Office Action Summary	Application No. 10/577,863	Applicant(s) ISHIHARA, MASAMICHI	
	Examiner WILLIAM HARRISTON	Art Unit 2826

DETAILED ACTION

2. Claims 1-7, 10-23 and 47-51 are rejected under 35 U.S.C. 102 (b) as being anticipated by Lee et al. (US 20050046002 hereafter Lee).

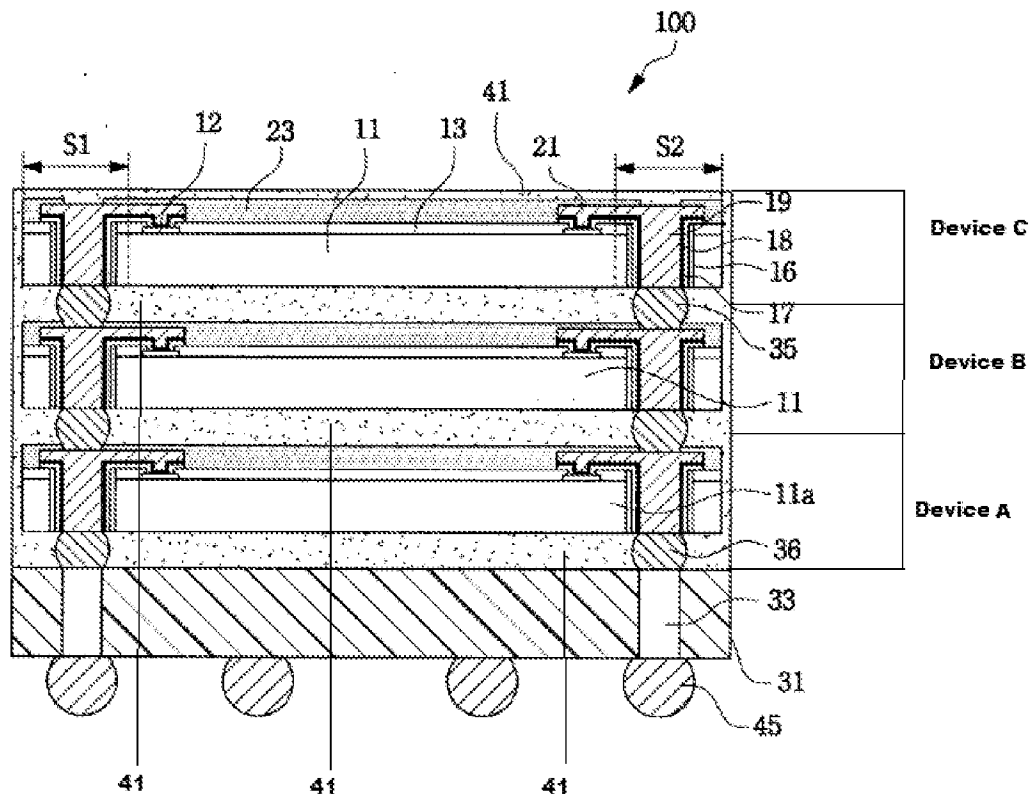
3. Examiner's note: To easily identify which common elements belong to which semiconductor device the Examiner has designated elements belonging to the first, second and third semiconductor devices with a, c, and b respectively.

4. Regarding claim 1, Lee discloses a stacked semiconductor device consisting of a first semiconductor device (Device A in annotated figure 3) having outside electrode terminals (36 in figure 3) on a lower surface thereof, a second semiconductor device (Device C in annotated figure 3) electrically connected with said first semiconductor device (See paragraph 0028 lines 1-3) and secured on said first semiconductor device, said first semiconductor device (Device A) comprising:

Examiner has interpreted a joint to be a location where two elements make contact.

a third semiconductor device (Device B in figure 3) stacked and secured between said first semiconductor device (Device A) and said second semiconductor device

the third through-type electrodes (19b in figure 3) on upper/lower surfaces of said third semiconductor device are electrically connected with the first through-type electrodes (19a in figure 3) of the first semiconductor device at an upper stage side and the second semiconductor device (11c in figure 3) at a lower stage side through joints (see paragraph 28 lines 1-3).

wherein said first and second semiconductor devices (11a and 11c in figure 3) are disposed as a single body, have a same size, and overlap each other. See paragraph 0032.

wherein a gap between said first semiconductor device (Device A) and said second semiconductor device (Device C) is filled with an insulating resin (41 in figure 3). See paragraph 0049 lines 1-3.

wherein said first and second post electrodes (35 in figure 3) have larger diameter than said first and second through-type electrodes (19a and 19c in figure 3).
